10. STEAM AND POWER CONVERSION SYSTEM

Chapter 10 of this safety evaluation (SE) describes the review by the staff of the U.S. Nuclear Regulatory Commission (NRC), hereinafter referred to as the staff, of Chapter 10, "Steam and Power Conversion System," of Mitsubishi Heavy Industries, Ltd., hereinafter referred to as the applicant, design control document (DCD) for the design certification (DC) of the United States - Advanced Pressurized Water Reactor (US-APWR). The steam and power conversion system removes heat from the reactor coolant system via four steam generators (SGs) and converts it to electrical power in the turbine generator. The main condenser condenses turbine exhaust steam, removes air and other non-condensables from the condensate and transfers waste heat to the circulating water system (CWS). The main condenser hotwell collects the condensate, which is removed by the condensate system. In the condensate system, the deaerator additionally deaerates the condensate, and supplies deaerated water to the regenerative feedwater cycle. The regenerative turbine cycle heats the feedwater, and the main feedwater system returns it to the SGs.

10.2 Turbine Generator

Figure 10.2-1; Electrical Overspeed Trip (EOST)

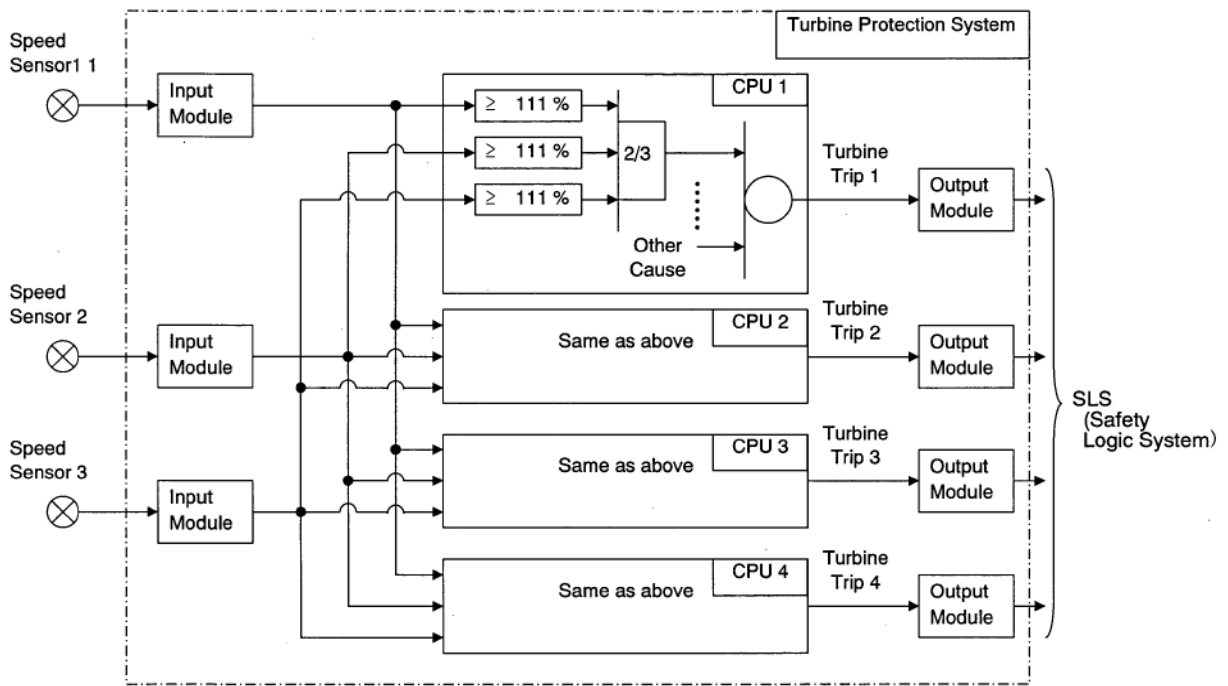
Upon review of the information provided in Section 10.2.2.3 of the DCD and its Subsection 10.2.2.3.2, "Turbine Protection System," the staff found that additional information was needed to establish the redundancy and diversity, and single failure considerations of the TG overspeed protection system and the MOST. Therefore, in **RAI 237-2141, Questions 10.2-2, 10.2-3, and 10.2-4 and RAI 598-4754, Questions 10.2-5, and 10.2-6**, the staff requested additional information for the overspeed protection system, and for the associated pneumatic and hydraulic fluid subsystems. Also, the staff requested schematics and logic diagrams for these systems to show how they function.

The purpose of the TPS is to detect undesirable operating conditions of the turbine, take appropriate trip actions, and provide information to the operator about the detected conditions. The TPS is independent of the TCS, including the speed sensors, as shown in Figure 10.2-1.

The emergency back-up electrical overspeed turbine trip at approximately 111 percent of the rated turbine speed is performed by the TPS and is designated as the EOST. The TPS closes the main stop, control, intercept, reheat stop, and extraction non-return valves resulting in turbine trip.

The applicant provided its responses to the above referenced RAI questions in letters dated March 25, 2009, and June 7, 2011, which included a DCD markup reflecting these responses. Additionally, as part of the response to Question 10.02-5, the applicant included Figure 1, "Overspeed Trip Device" and Figure 10.2-3, "Simplified schematic of turbine control and protection system." Also, Figure 2-1, "Schematic and Logic Diagram for Emergency Back-up Electrical Overspeed System," was included in response to Question 10.2-2. These figures were included to depict the redundant and diverse features and functional performance of the overspeed control systems. Based on its review of the responses and DCD markup, the staff identified the following information:

Figure 10.2-2: Turbine Trip Block

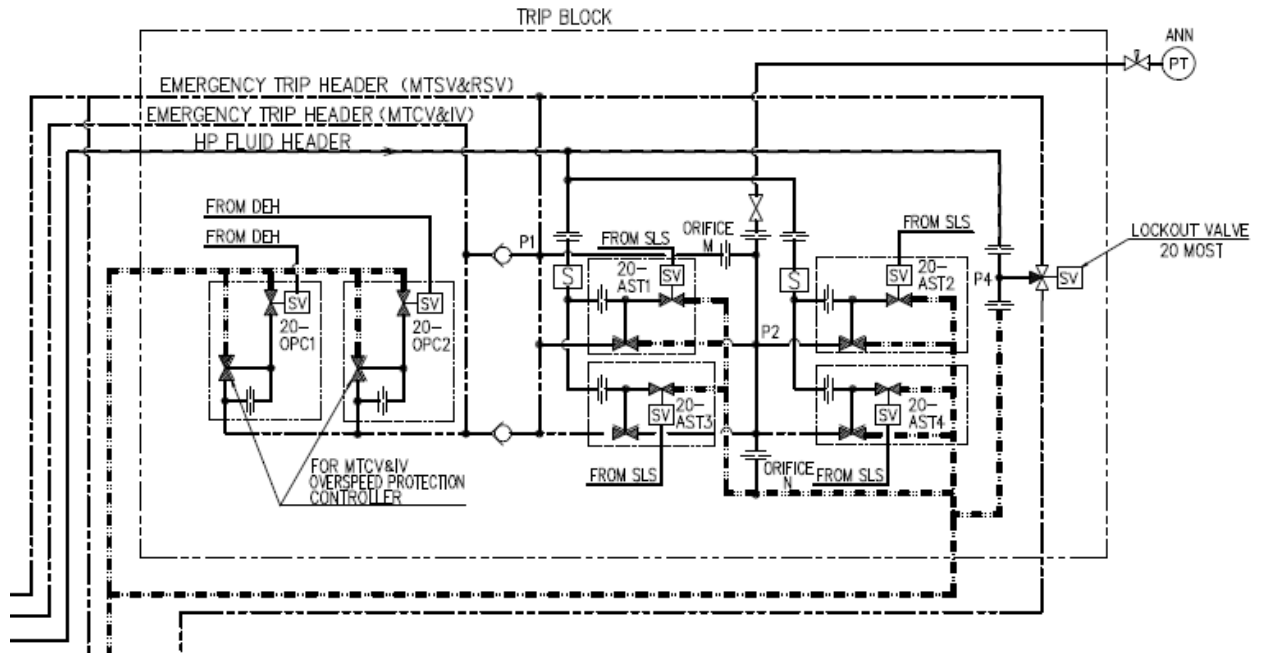
The TPS trips the turbine by opening four turbine trip solenoid valves to drain the emergency trip header hydraulic fluid. The TPS is independent from the TCS, including the speed sensors, as show in Figure 10.2-1. The TPS cabinet consists of quadruple-redundant microprocessors and redundant power supplies. Each microprocessor corresponds to each trip solenoid valve. Each TPS output module provides an independent turbine trip command (normally closed contact) to its corresponding trip solenoid valve via the Power Interface module of the Safety Logic System (SLS). This hardwired interface between the TPS and the safety-related SLS is evaluated in Section 7.3 of this SE. Failure of a TPS microprocessor or its redundant power supply initiates a turbine trip command (open contact), which results in de-energizing of the corresponding turbine trip solenoid valve, thus allowing the valve to open under internal spring force and dump steam valve hydraulic pressure. The TPS is designed as a fail-safe system. The emergency trip header pressure is established when the turbine trip solenoid valves are energized and closed. The valves are arranged in two channels as shown in Figure 10.2-2. At least one solenoid valve in both channels must open (de-energize) to trip the turbine. This arrangement allows testing of each channel without tripping the turbine, and prevents turbine trip due to failure of a single component.
